# SERVICE BULLETIN

SB1242

| <b>VEHICLE MODEL</b>          | : C2045 New Look   |
| <b>SUBJECT</b>                | : <b>Evaporator door retention</b>   |

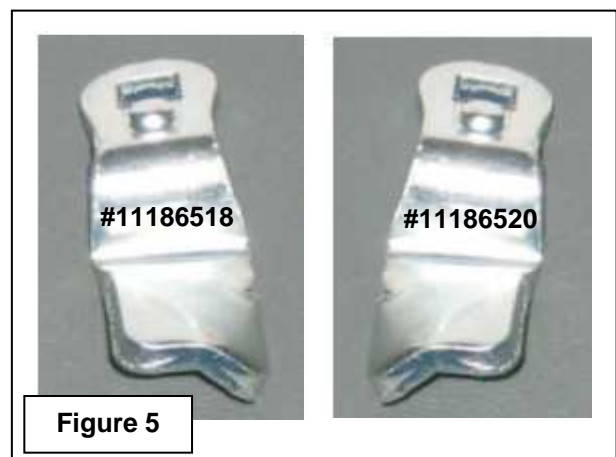
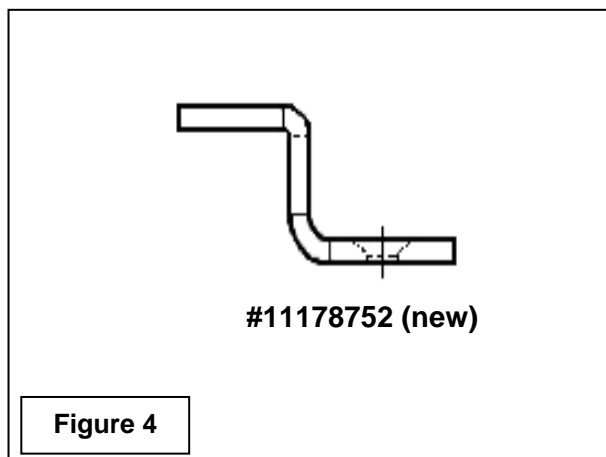
1. Service records have shown that on the above-mentioned units evaporator door retention issues may be encountered.
2. To address these issues, a product improvement has been developed, which entails the installation of new, unidirectional door latches and differently shaped retaining angles.
3. This Product Improvement Bulletin has been released to inform customers of the new developments.  
Therefore, should evaporator door retention issues be encountered on your vehicle, you may refer to the materials list and apply the step-by-step instructions from the procedure.

| VH reference | Description                                | Qty. | Refer to |
|--------------|--|------|----------|
| 11002595     | Angle, evaporator door retaining, aluminum | 2    | Figure 2 |
| 11080756     | Latch, bi-directional                      | 6    | Figure 3 |

| VH reference | Description                      | Qty. | Refer to |
|--------------|----------------------------------|------|----------|
| 11178752     | Strip, Z-shaped, stainless steel | 2    | Figure 4 |
| 11186518     | Latch, left-hand                 | 5    | Figure 5 |
| 11186520     | Latch, right-hand                | 1    | Figure 5 |

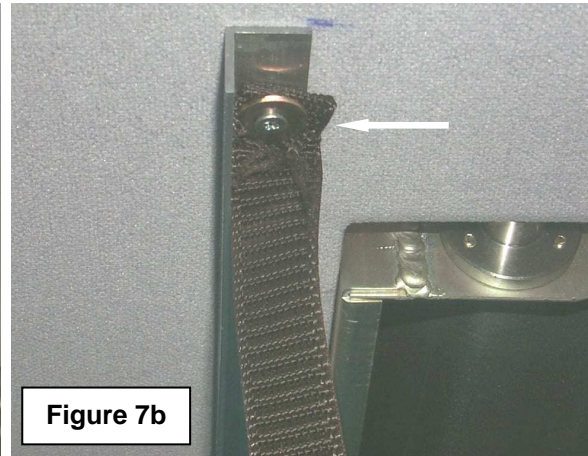
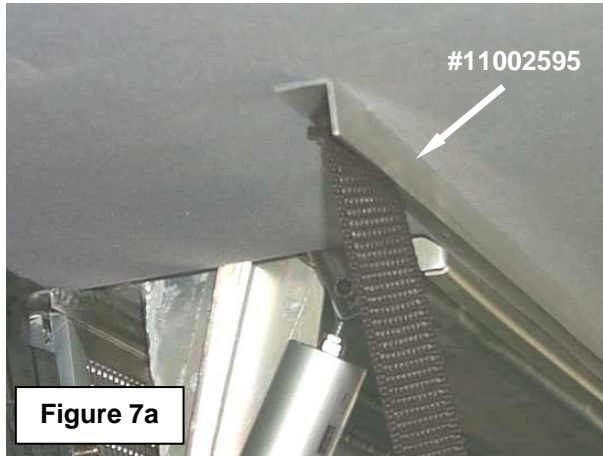
- 2) Angle #11002595 (Figure 7a) has been attached to the roof frame by five screws. Undo and remove the screws securing the check straps on either side of the angle (Figure 7b). Recover the check straps and fasteners. Undo, remove and recover the remaining fasteners. Remove and discard the angle.

- 3) Using the existing screw holes in the roof frame as a reference, install z-shaped strip #11178752 with the recovered fasteners as shown in Figure 8. Install the recovered check straps. Secure all fasteners hand tight.

**Figure 9**

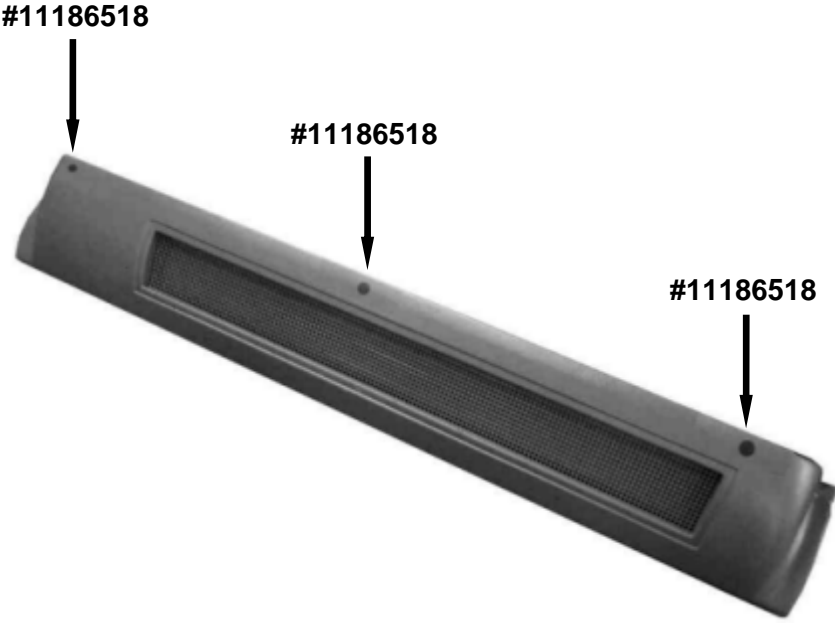
*NOTE: Old latches are bi-directional (Figure 3) with shallow curvature. New latches are directional with pronounced curvature to one side. Refer to Figure 9 for the location on the evaporator doors of new latches #11186518 and #11186520.*

- 2) Refer to Figure 9 to determine the replacement latch required for the location.  
Install the new latch in reverse order to the removal of the old one.  
Secure the center bolt hand tight.
- 3) Reinstall the evaporator doors in reverse order to removal.
